Iowa City Historic Preservation Commission

IOWA CITY HISTORIC PRESERVATION COMMISSION

Thursday, October 10, 2019

Staff Report

601 DAKLAND AVE
LANA CITY, IA

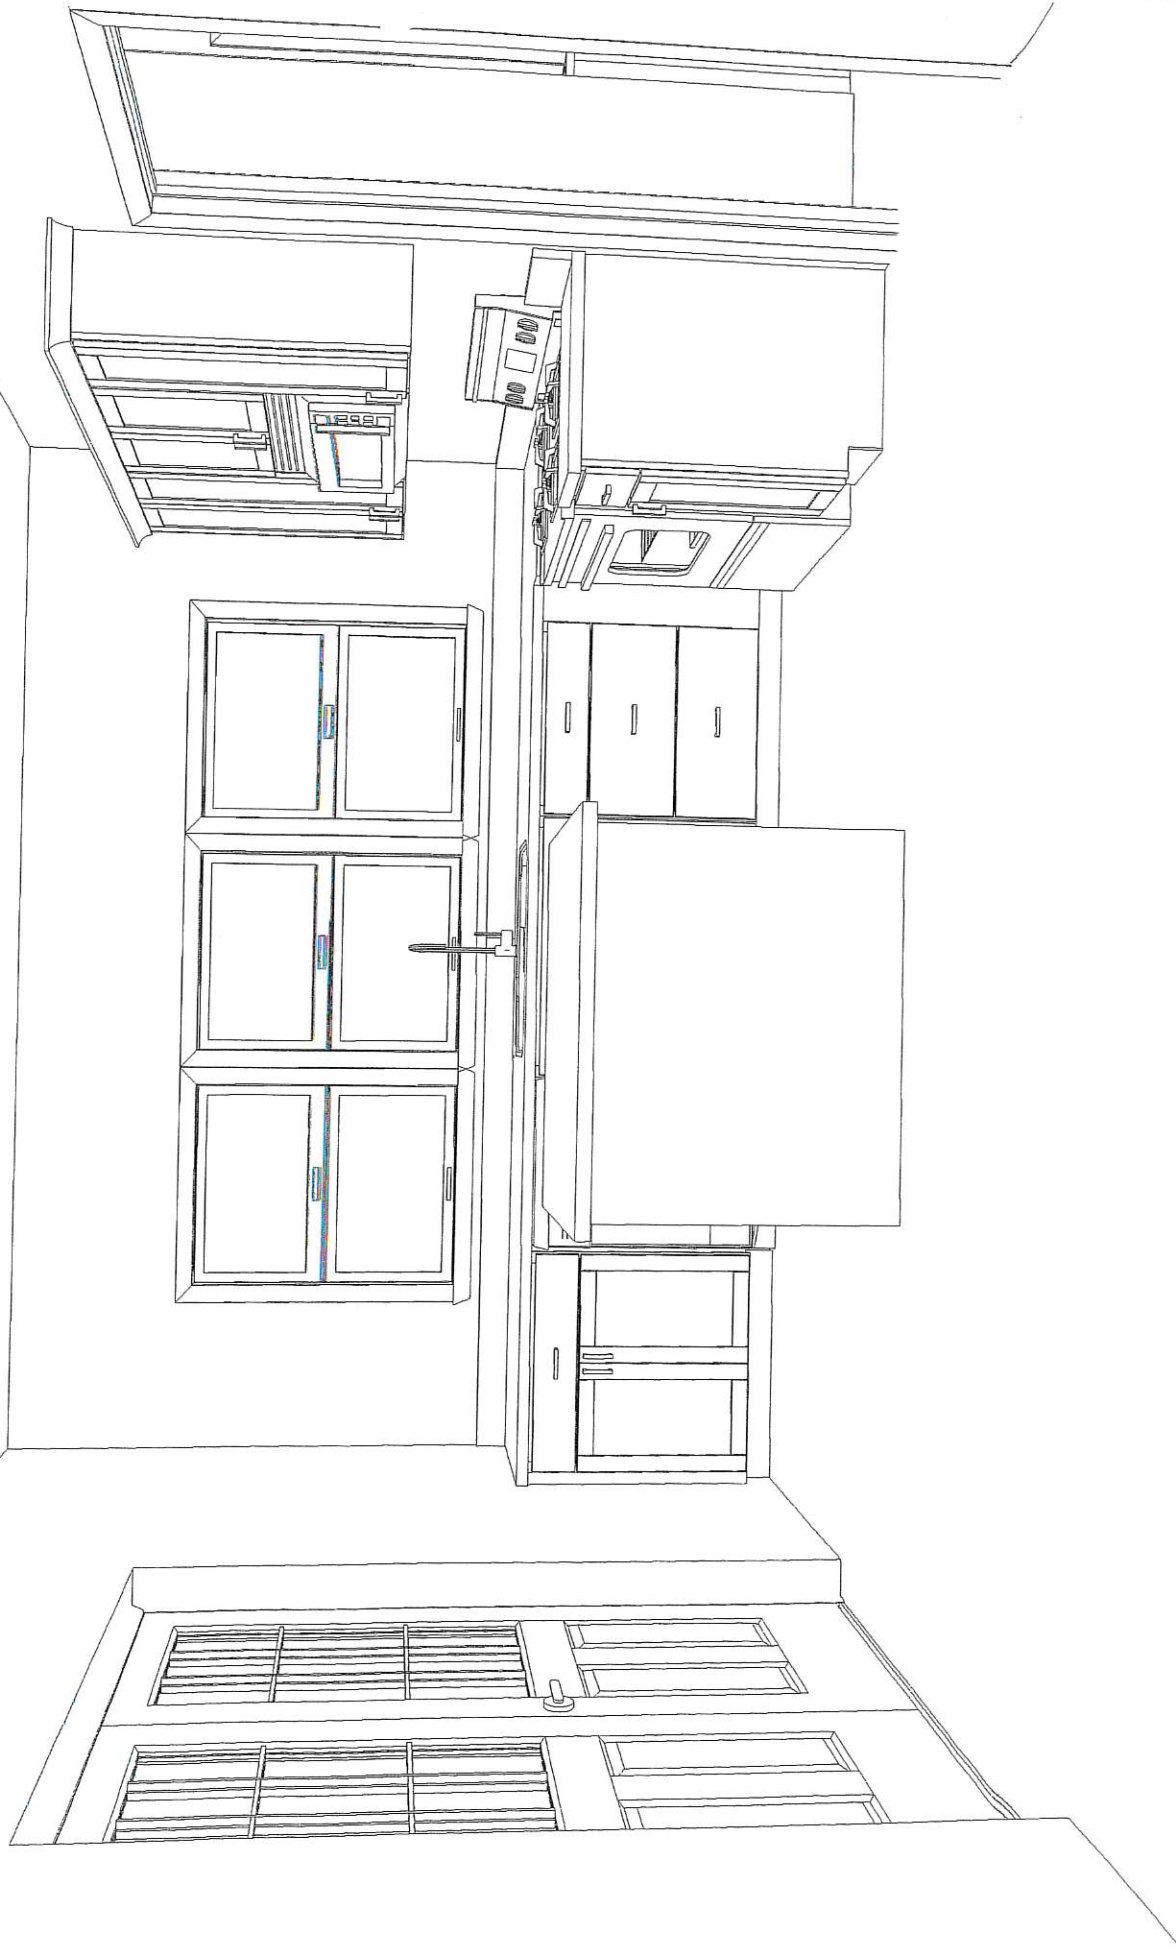
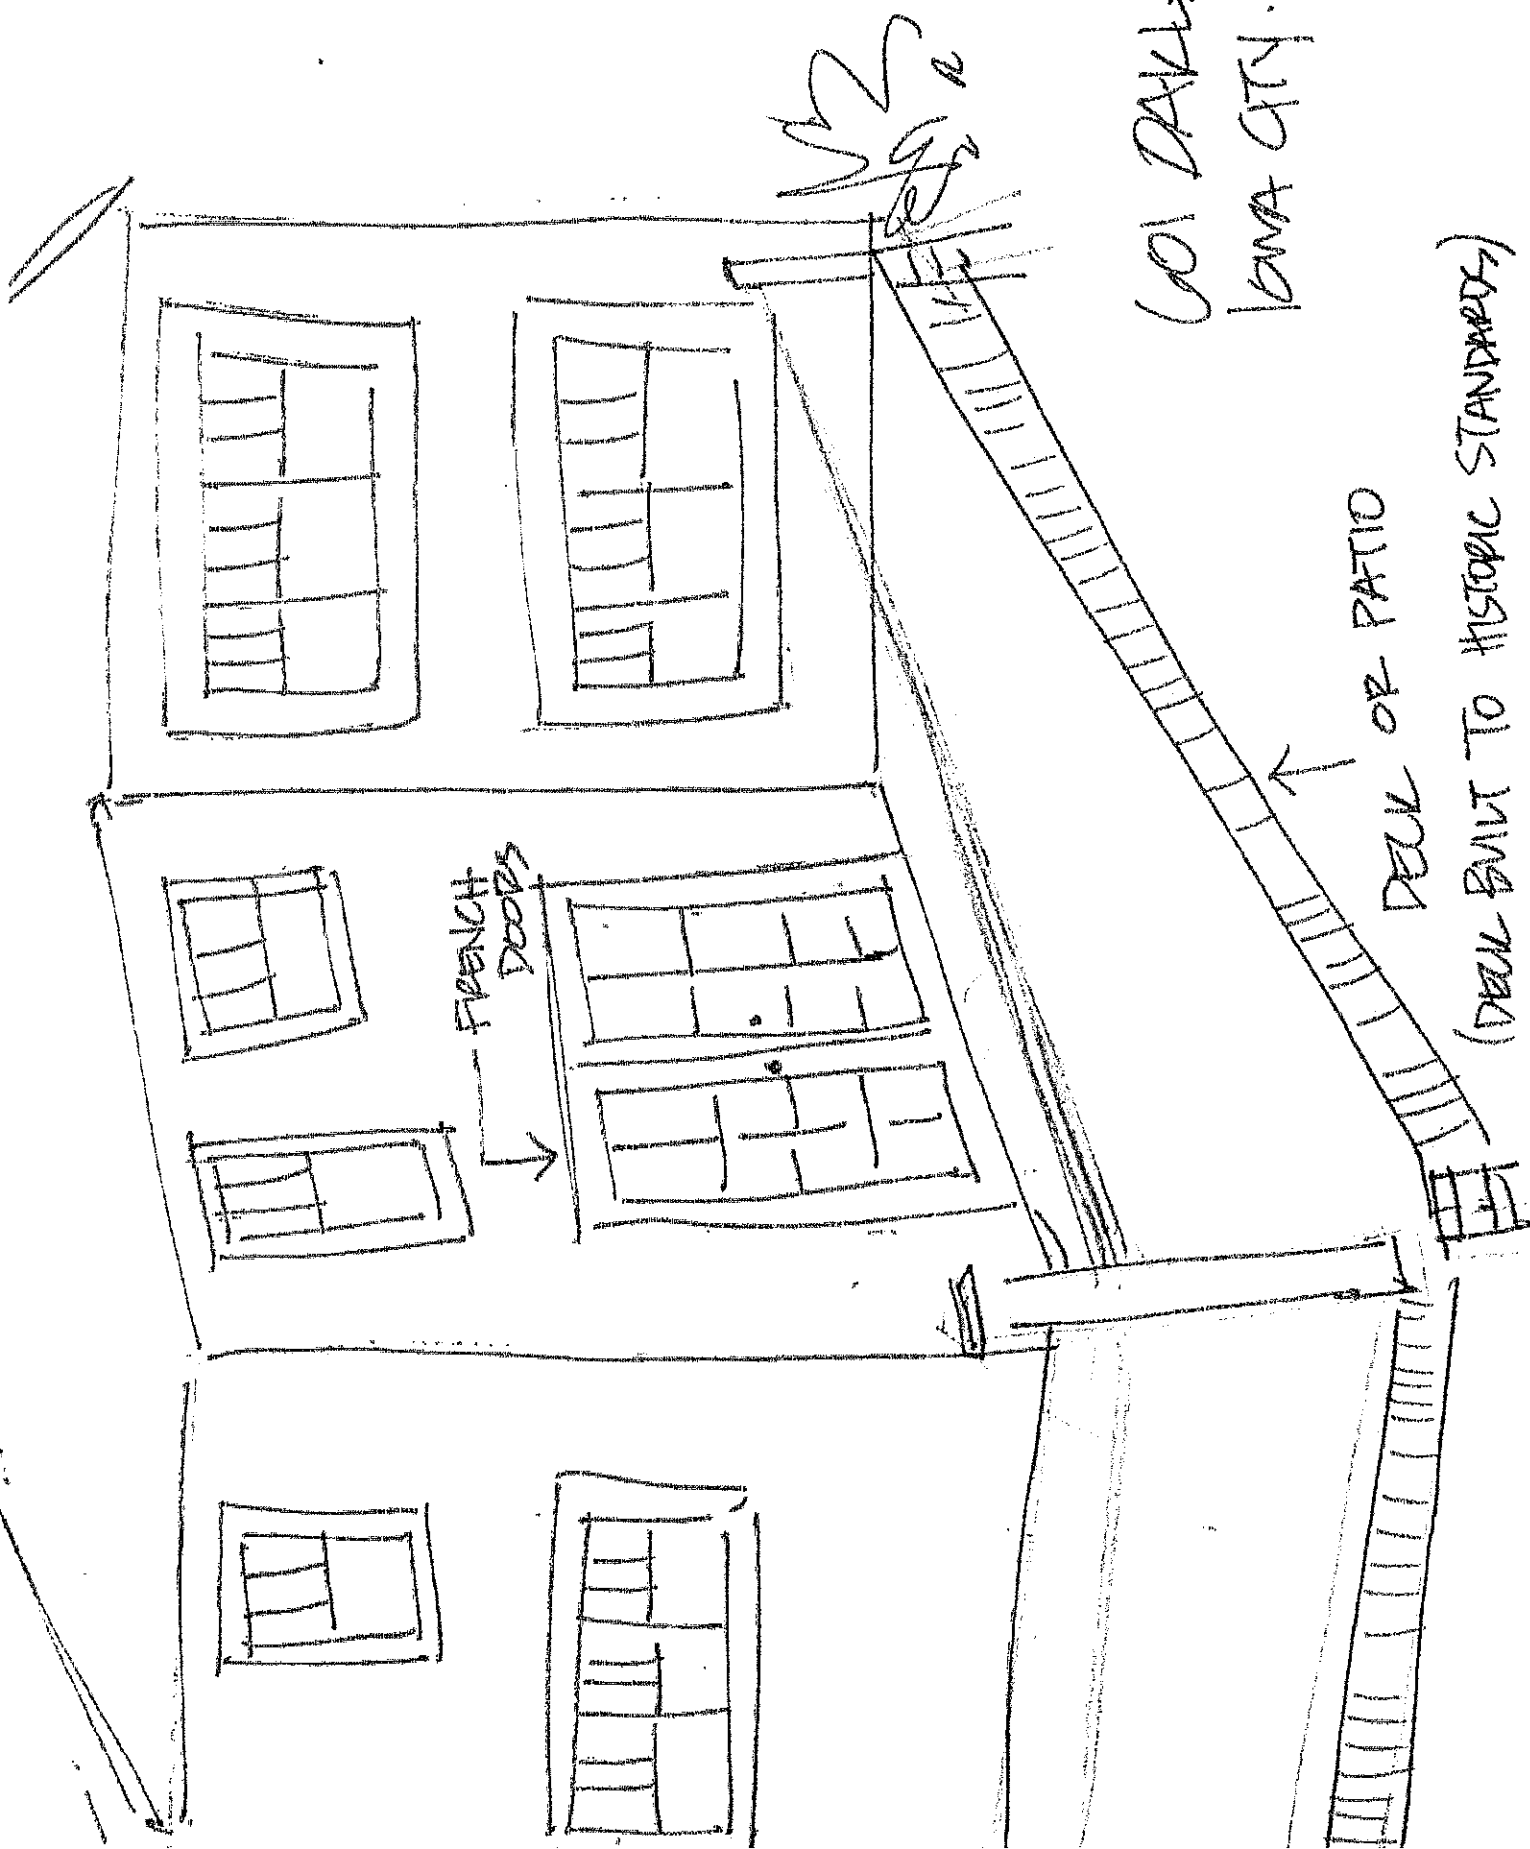
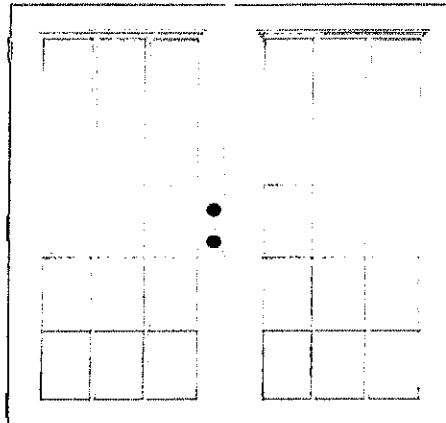
The applicant is proposing to replace an original, existing pair of windows, located on the south side behind the bump out, with a pair of French Doors. The property is currently undergoing an extensive rehabilitation project for which this window to door change is only one element. Additional portions of the project will include: the rehab of the original rear open porch; the removal of a non-historic refrigerator alcove; painting and repair of the existing siding, painting of the garage, and the construction of either a patio or a deck that is accessed through the new doors. Interior changes will relocate the kitchen from the Northwest corner of the house to the southwest corner. Exterior access for entertaining will be achieved through the new doors. The new French Doors will fit within the width and height of the existing windows, requiring very little additional trim. The new trim will match the existing. It will also be suggested that the pair of windows preferably remain with the house but are otherwise donated for salvage instead of being sent to the landfill.

In Staff's opinion, the location of the new door is toward the back of the property and obscured from the street by the south bump-out on the house and therefore in an acceptable location. By replacing an existing pair of windows with a pair of doors, the impact of the change to the structure and pattern of openings is minimized. The proposed new doors are fiberglass, which meets the guidelines for wood substitute. The new doors will also have simulated divided lites because the windows on the house have divided lites in the upper sash. Staff recommends approval of the project.

1127 Maple St.
Garage

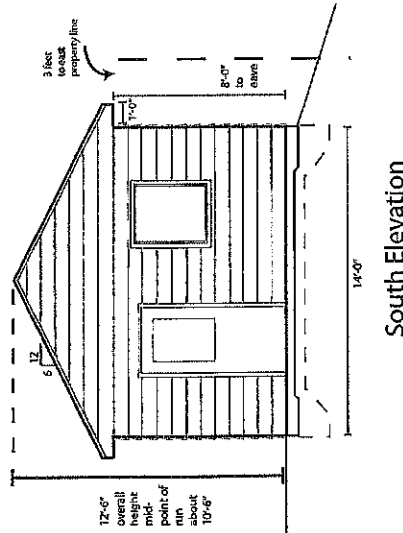
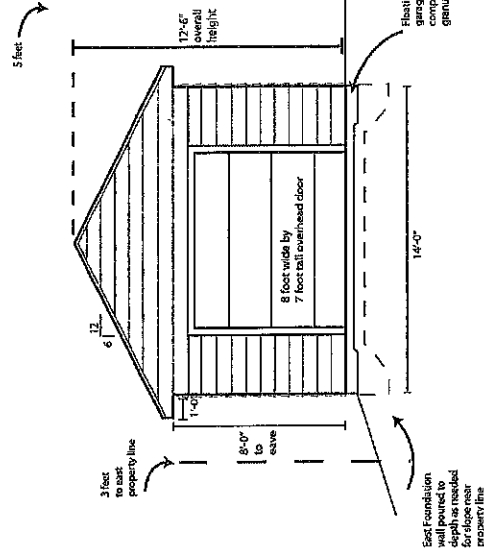
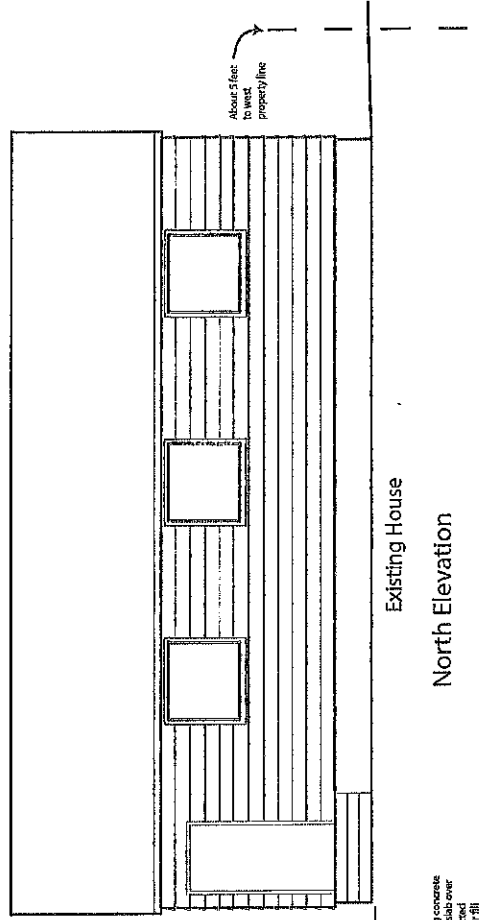
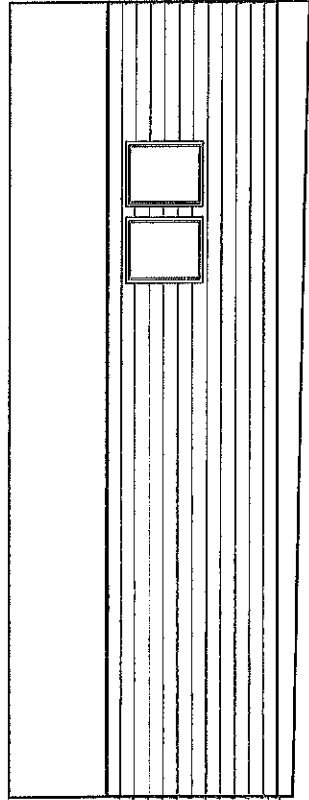
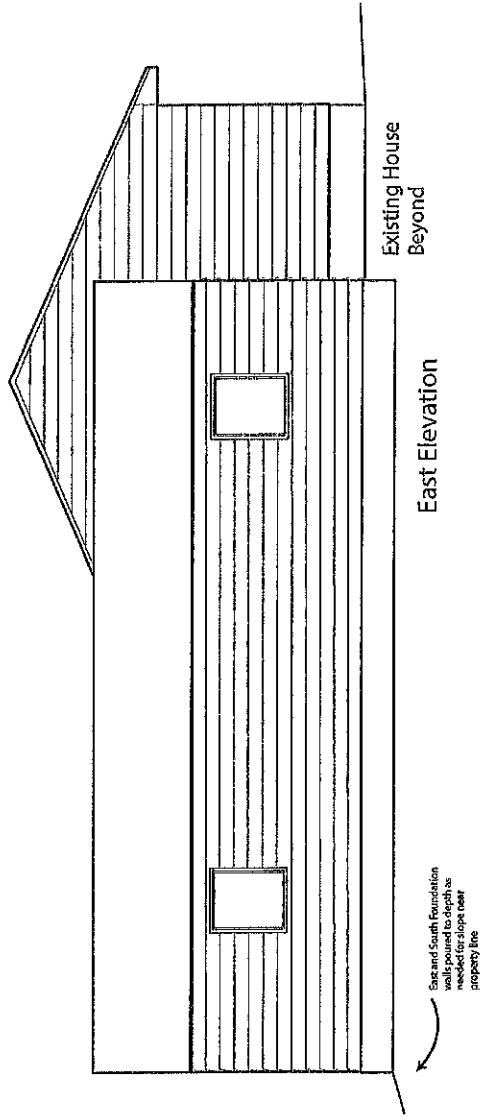
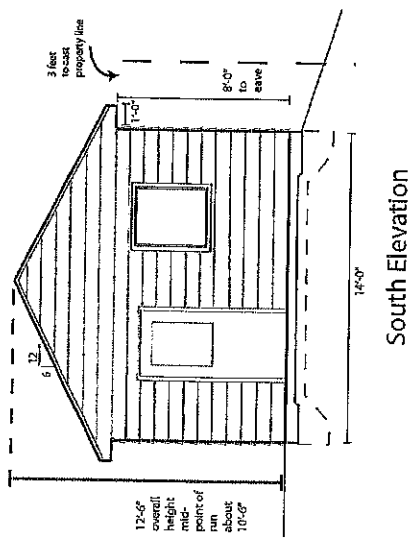
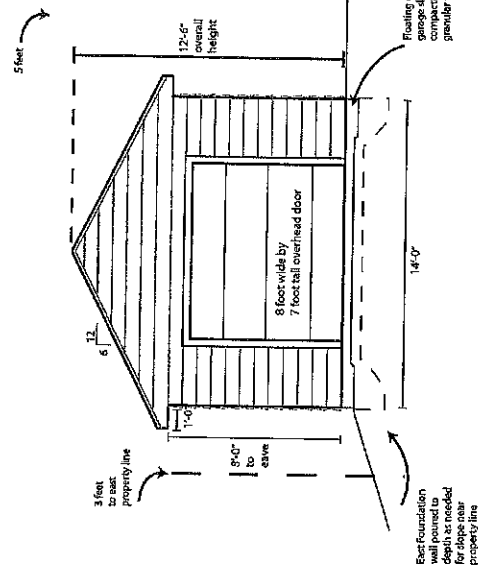
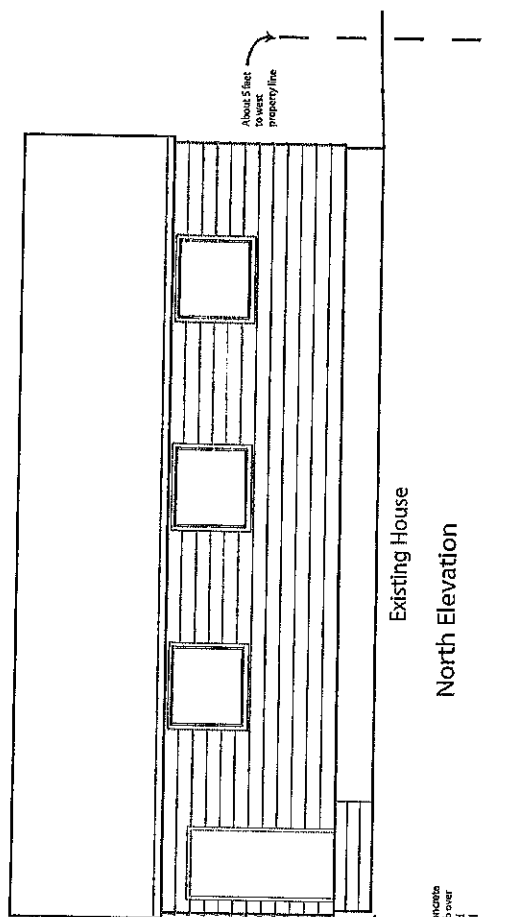
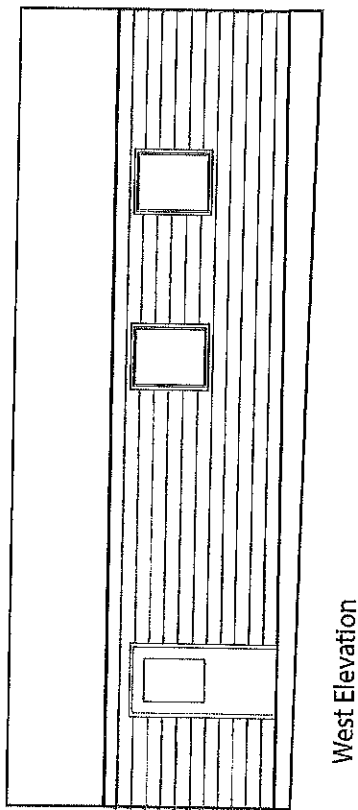
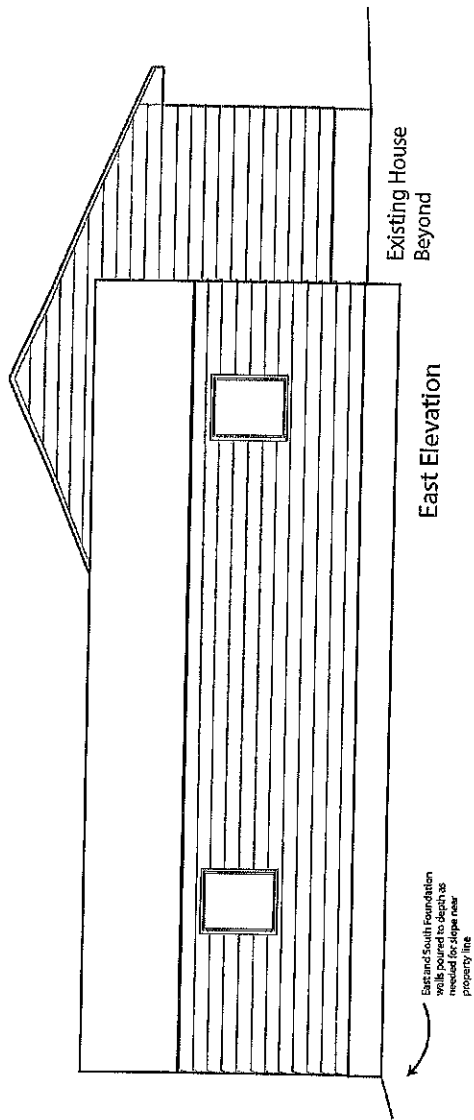
The applicant is proposing to remove the non-historic small shed (for which they need no approval or permit) and construct a new garage with extra length to accommodate storage and work area. The new garage will have appropriate roof material to match the house, and cement board siding with a lap of about 6 inches which is slightly smaller than the house. The eave condition of the house, as well as the roof pitch, will be matched in the new garage. The garage will also have double-hung windows in a proportion that it more similar to the house than to most historic garages reviewed by the Commission. The single-car overhead door will be a smooth flat-panel door.

The new garage will be set back 60 feet from Maple Street, allowing them to reduce the side setback to 3 feet. A 5-foot space will provide access to the back yard between the house and garage. Because this space is not 6 feet or more, the garage will require fire-proof construction of the wall adjacent to the house. Two elevation sheets are submitted with the application, showing two options for this west-facing wall of the garage. One option has a passage door and two windows spaced similarly to those on the east side. The other has no passage door and two windows located beyond the rear corner of the house. In addition, the applicants may wish to have a second overhead door on the south end of the garage instead of a passage door and window.
